ET5209-510A (ET-49B)
 (P/N 7520951000)
 (Etch mask 2291033002 or 052-471B)
 Serial Number with 9100

ET-49(151-049)
 (Etch mask 052-471)

SG 01 (ET-49B) 0

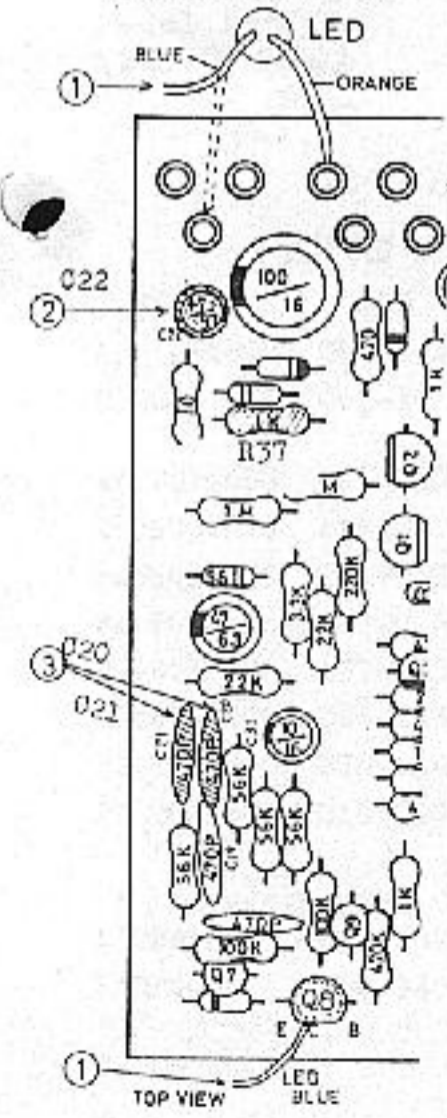
On later products HEC-0317-1-1 is employed as AC adaptor jack for positive connection. The change involves redesigning of mounting hole in cases because of size difference between two jacks. HEC-0003 only can enter the holes in new and old cases.

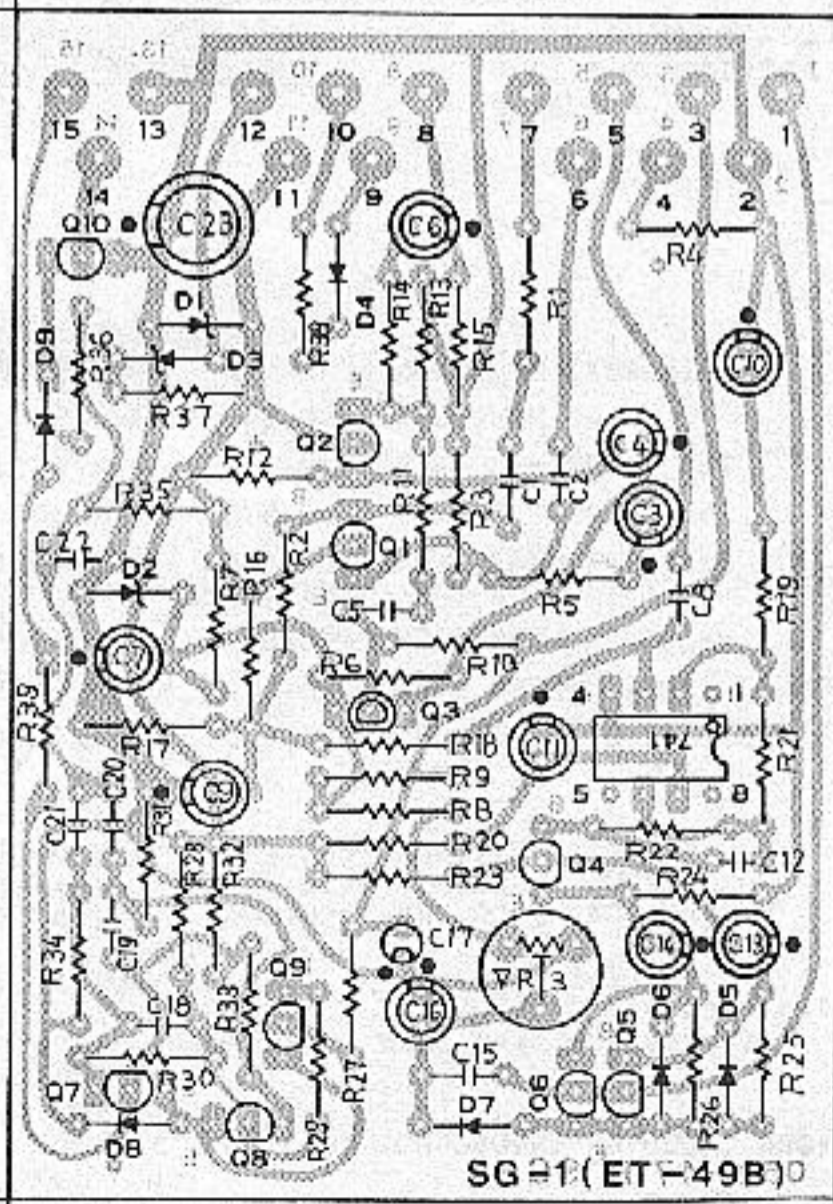
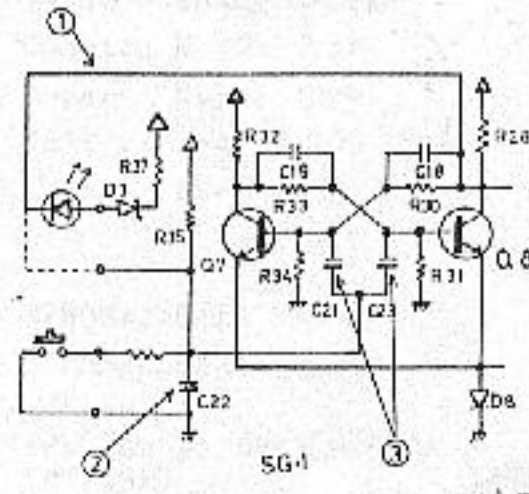
LED connecting to ET-49 does not light continuously in effect mode since circuit is so arranged. The following for the modification for keeping LED lit.

1. Shift LED blue wire to Q8 C.
 2. Replace C22 (1/50 or 0.4/50) with 0.01 mylar.
 3. Replace C20 and C21 (470pF) with 220pF for stable flip-flop at lower DC supply (6-7V).
- For long battery life, low-power-consumption LED SLP-135B is incorporated with later PCB. When changing LEDs, also change R37 1k to 3.9k ohms.
